SYDNEY SWANS HQ & COMMUNITY CENTRE ROYAL HALL OF INDUSTRIES

RESPONSE TO GA NSW PLANNING SUBMISSION

PLANNING RESPONSE DOCUMENT – CMPT COMMENTS

New toilet amenities to cater for the office fit out and for event use.

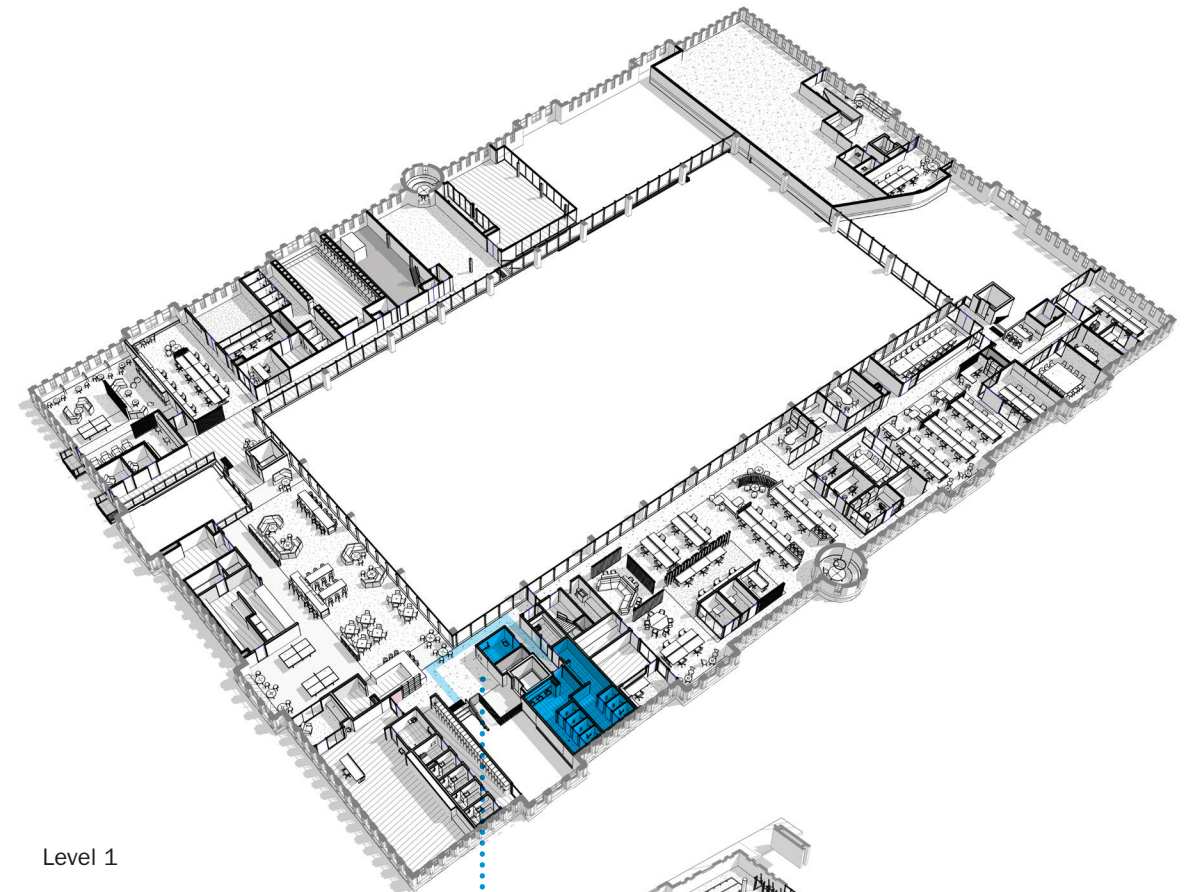
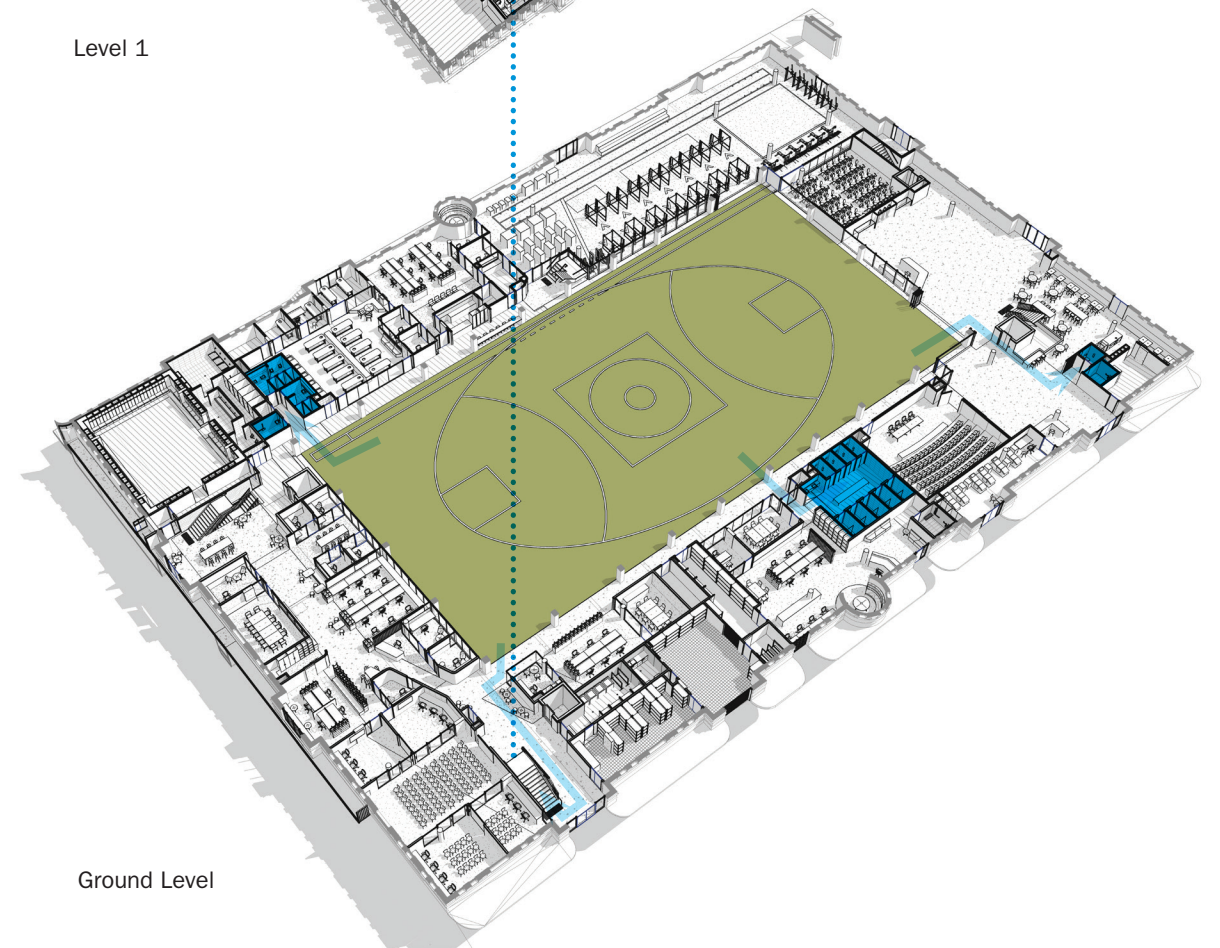
Reconsider the location of the proposed RHI toilets to ensure they service the office fit out and are easily accessed during events.

The basement toilets previously used in event mode are outdated, no longer meet NCC requirements and no longer fit for purpose.

We are proposing to close these down and provide new facilities throughout the building which, when operating in an event mode can be used. These toilets are shown in the images to the right. Only toilets at Ground Level will be able to be used with no access to Level 1.

These toilets will be used by staff during normal working hours. the design allows for the toilets to be accessed by people in an event on the Multi-Purpose Area whilst not accessing the private areas of the Sydney Swans work area.

Entry Foyer connection to plaza

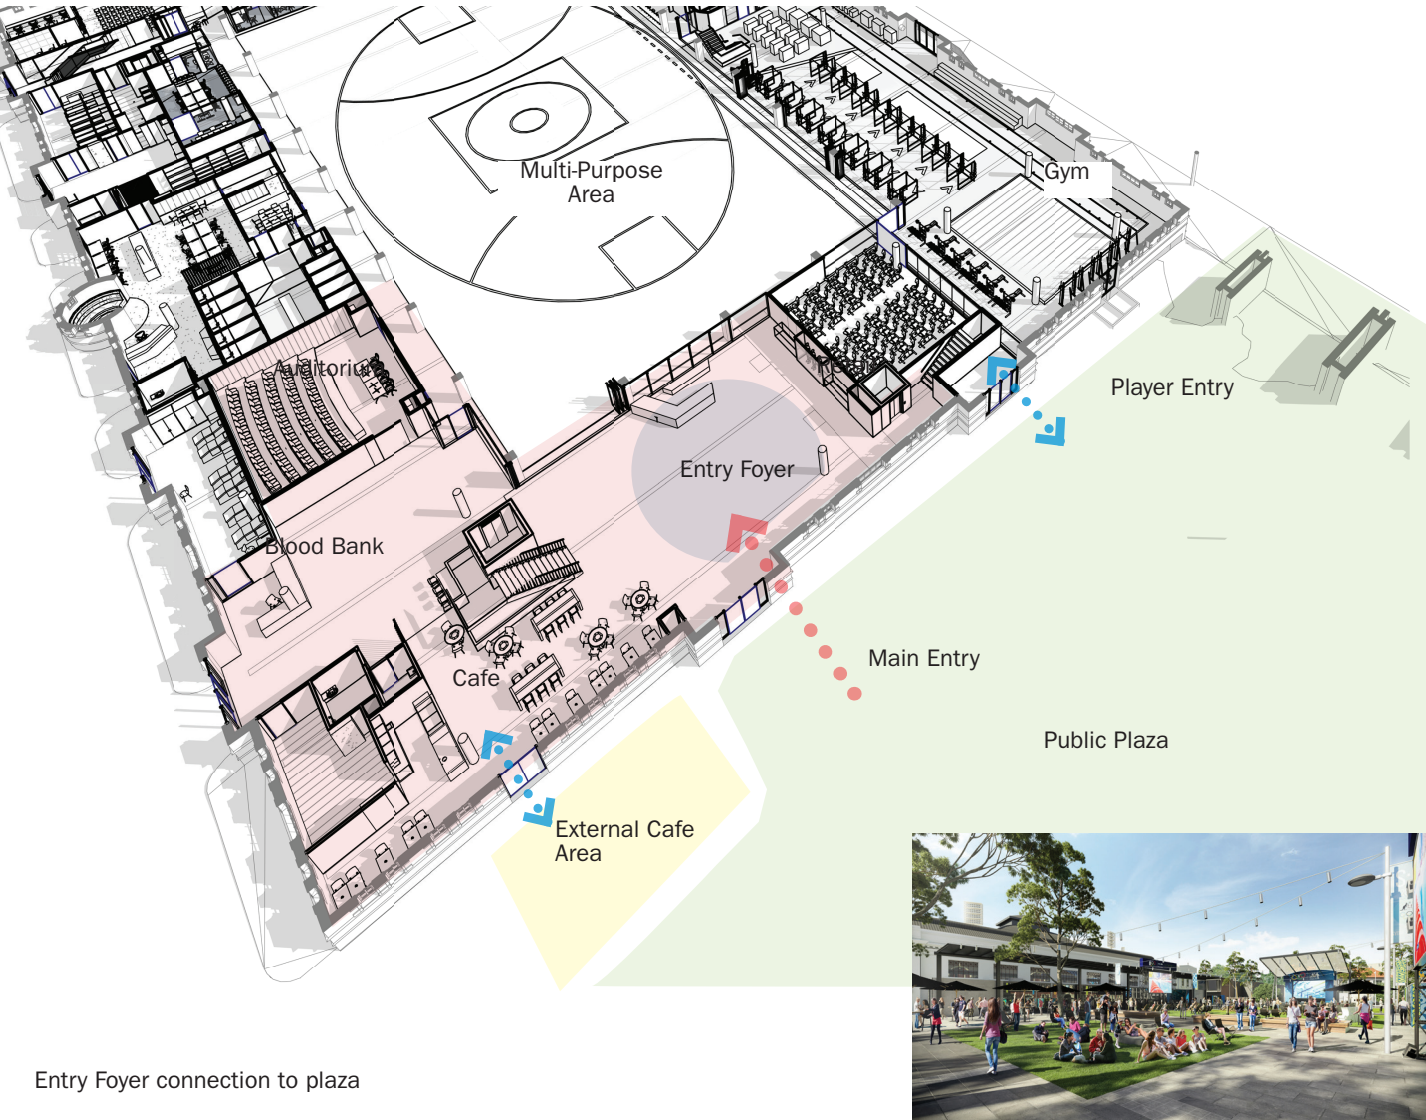
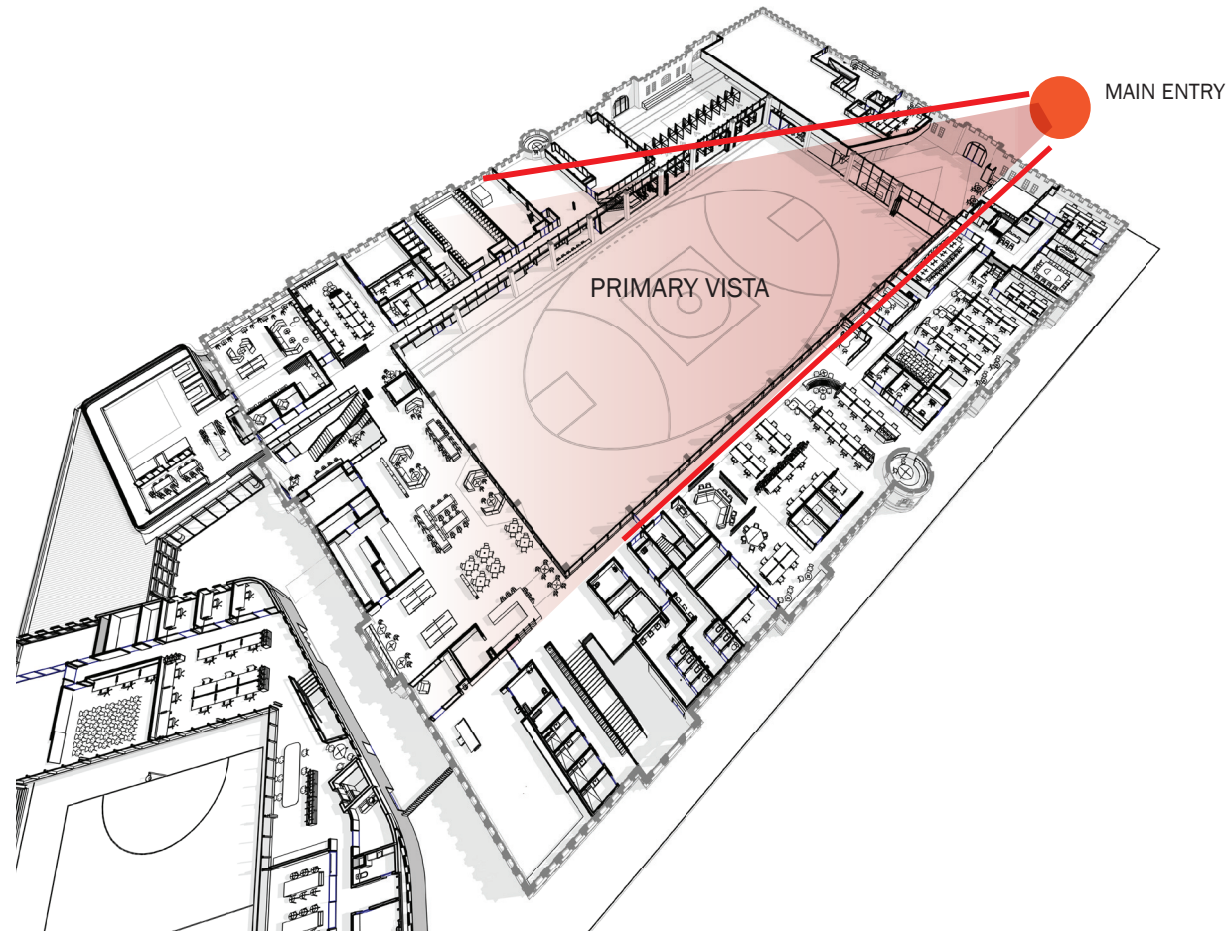
Enlarge the entry from the plaza into the RHI to strengthen the internal/external relationships and showcase the volumes of the existing RHI.

The ability to enlarge the entry and strengthen the internal/ external relationships is limited by the size of the existing doorways which are fixed.

The entry foyer is appropriately proportioned and still showcases the sense of volume of the RHI, especially upon initial entry into the building. This is accentuated by maintaining a visual vista to the primary volume of the building being the central barrel vaulted space.

Also given the key adjacencies between spaces there is limited ability to 'swap' program around in order to aggregate void spaces.

The existing columns are bordered by circulation corridors for the majority of the RHI.

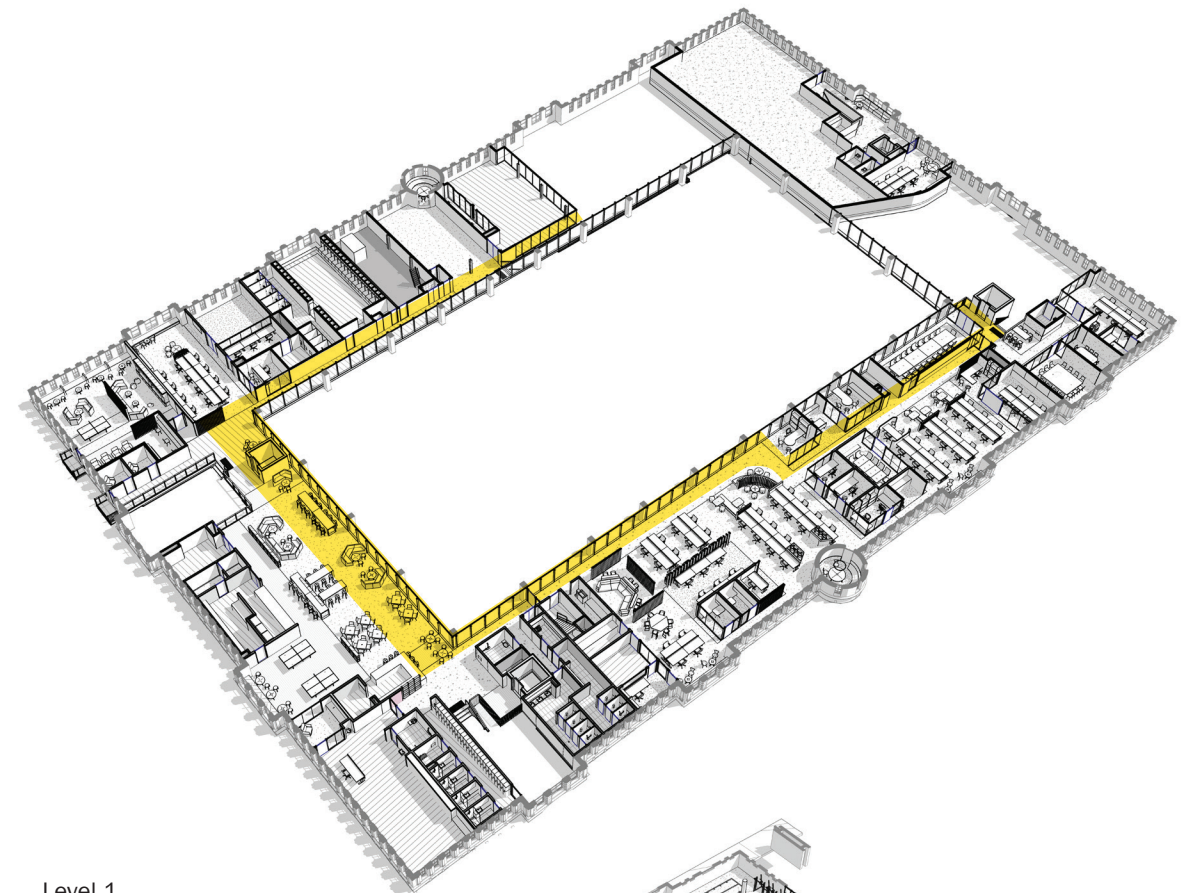
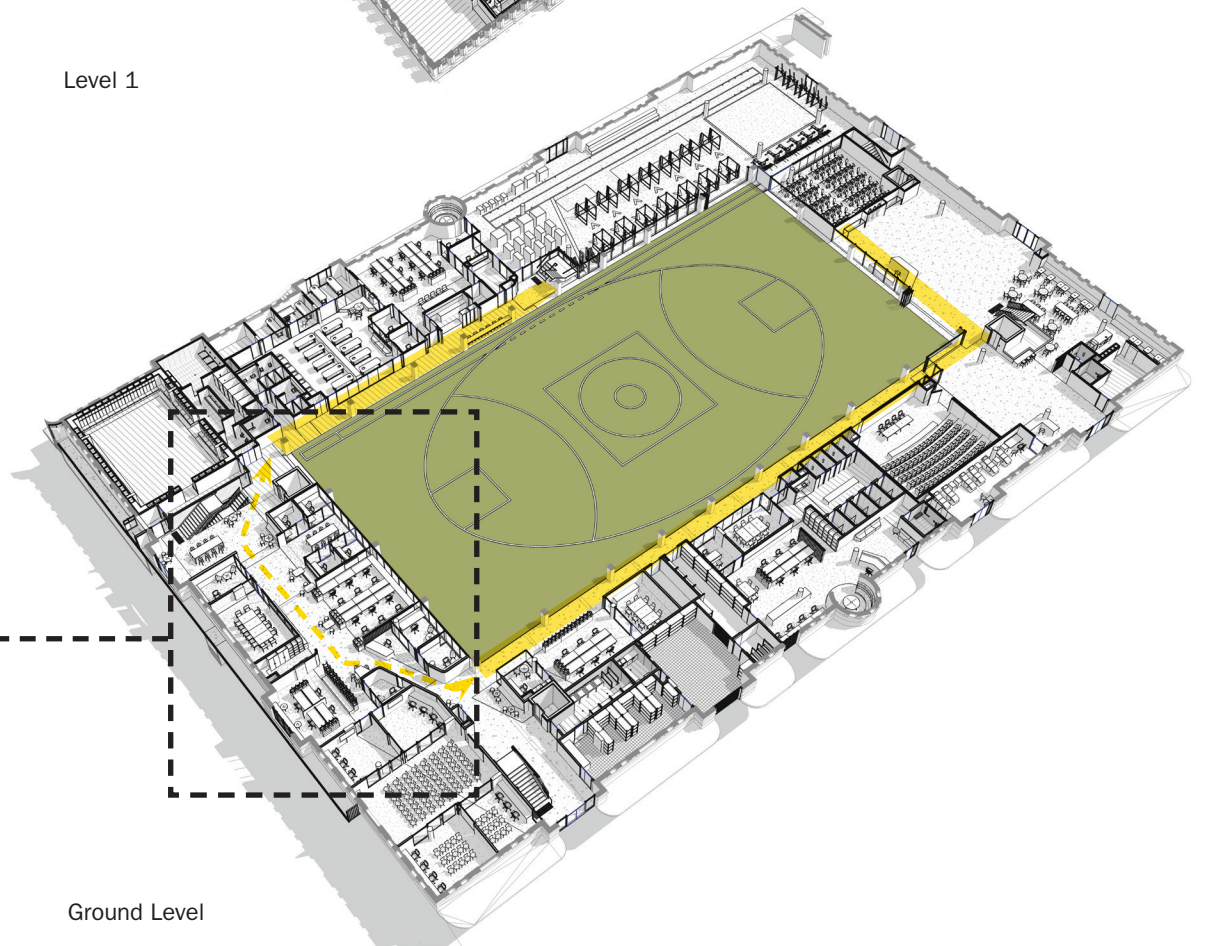
Provide a walkable space/corridor around the outside of the internal colonnade in the RHI.

A walkable corridor has been provided for the majority of the internal colonnade. The exception being the South where it was desired from the client that the building users would benefit from having access directed through the football department to encourage interaction and collaboration between coaches and players. Regardless, the layout in that area has been designed so as to align walls with columns so the colonnade is still clearly expressed (see image below).

On Level 1 the glazing is offset from the column and is viewable from a mostly continuous circulation route which guides users through the administration area through the club dining hall and to the players areas on the West. Where there are rooms adjacent to the columns instead of circulation space, glazing is offset to the column to ensure the column is visually expressed and physically independent to the new build.
